Senior Regulatory Economist Network Rail Kings Place, 90 York Way London, N1 9AG

Proposed Rules Change: Scotland electrification – changes to ESTA boundaries

The proposal we are consulting on is to amend the ESTA descriptions in Appendix 5 of the TER. The proposed change is to add "Barnhill" as an additional boundary point in the descriptions of both ESTA E and S.

Figure 2: Proposed ESTA configuration in the Glasgow area from May 2014

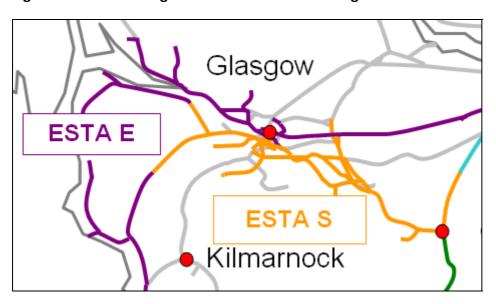
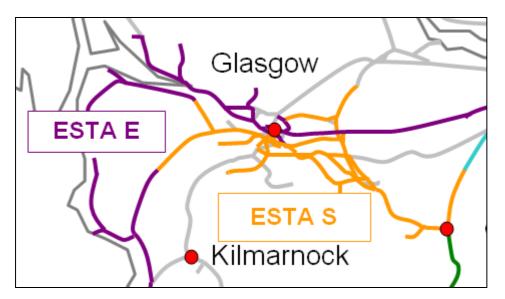
- Springburn to Cumbernauld: In March 2014, a new neutral section was installed near Barnhill station, just south of Springburn. Since just one new neutral section was installed at the western end of the new section, it is not possible to separately switch the new section which means there is only one possible feeding arrangement. The section of line north of the neutral section is supplied from Parkhead GSP (grid supply point) in ESTA E and the much longer section to the east of the neutral section is supplied from Gowkthrapple GSP in ESTA S; and
- Rutherglen to Coatbridge: In August 2014, this line will be supplied from Eglinton Street and Gowkthrapple GSPs. Both of these GSPs are in ESTA S, therefore there is only one option for this section.

ESTA	Traction electricity Geographic Area / Tariff zone	Description
S	Scotland Glasgow	Comprises the electrified routes in Scotland between the neutral sections at <u>Barnhill</u> , Coatbridge, Rutherglen, Bishopston, Lochwinnoch and Carstairs and Auchengray (between Edinburgh and Carstairs).
E	Scotland North & West	Comprises the electrified routes in Scotland on the North Clyde bounded by the neutral sections at Barnhill , Coatbridge, Rutherglen and Haymarket; the routes from Bishopston neutral section to Gourock and Wemyss Bay and the routes from Lochwinnoch neutral section to Ayr and Largs.

A diagram of the proposed ESTA configuration is illustrated in Figure 2 in Annex A.
